PLANNING & ENVIRONMENT ACT 1987  
 WHITTLESEA PLANNING SCHEME  
 Planning Permit No: 716630  
 Endorsed to show compliance with Condition (s) 3  
 Sheet 1 of 2 Date: 03/09/2021

**RATHDOWNE ESTATE STAGE 14 FUNCTIONAL LAYOUT**

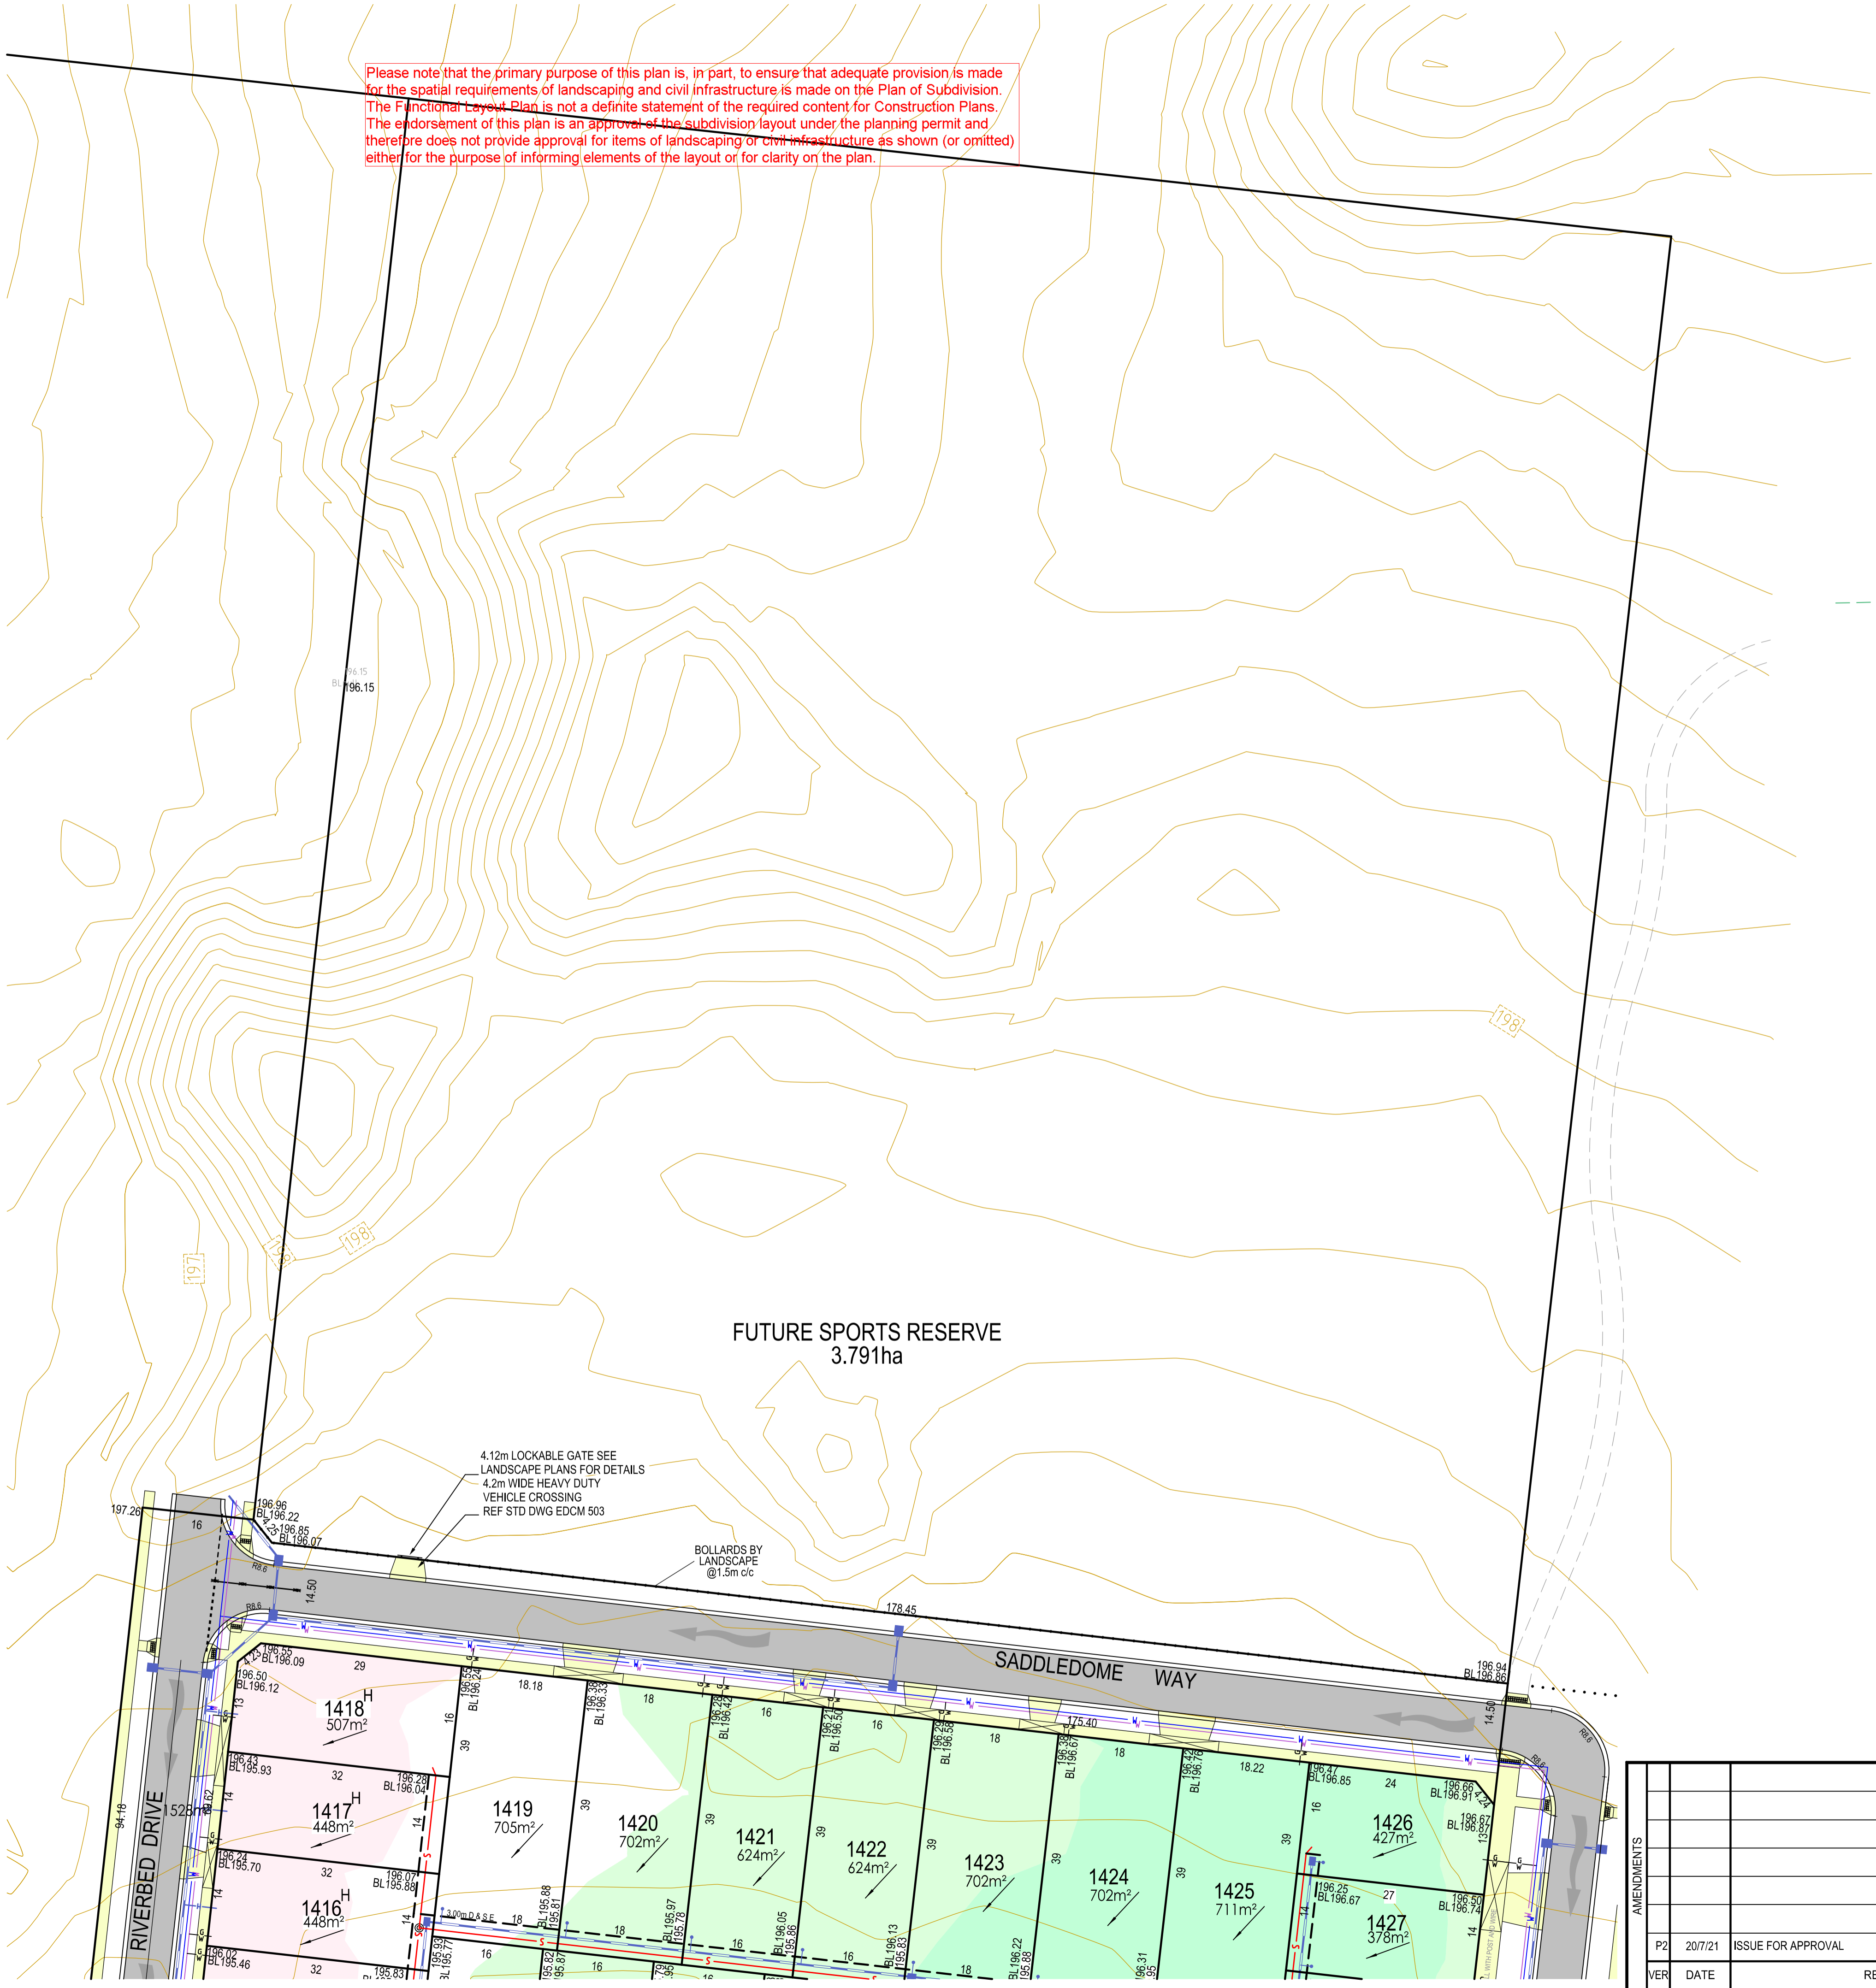
The following general notations apply to the approval of this FLP:  
 - A copy of Melbourne Water's approval for the main drain must be submitted as part of the civil plan submission.  
 - Design and location paths, gaps in dry stone wall and stone wall for reconstruction, retention, restoration or removal must be identified with the detail design submissions. Detail design submissions showing this must be reviewed by Councils Growth Area Development Assessment Department as part of the civil and/or landscape plan assessment to confirm compliance with the endorsed Dry Stone Wall Management Plan.  
 - In accordance with the existing Veerings Road Delivery Plan, the western side of Veerings Road, north of Blunsdon Road is to be completed with Stage 13 civil works. Installation of a 4.2m wide heavy duty vehicle crossing REF STD DWG EDMC 503.

Conditions applying to this approval which must be shown on the civil plan submission:  
 - All required services must be identified.  
 - Bus stop locations (or indicative locations) must be shown to the extent required by DoT and Council.

In the event bus stop or service location impacts the path network, road pavement alignment, lot or road boundary, the applicant must provide a plan showing the proposed location of the bus stop or service location.
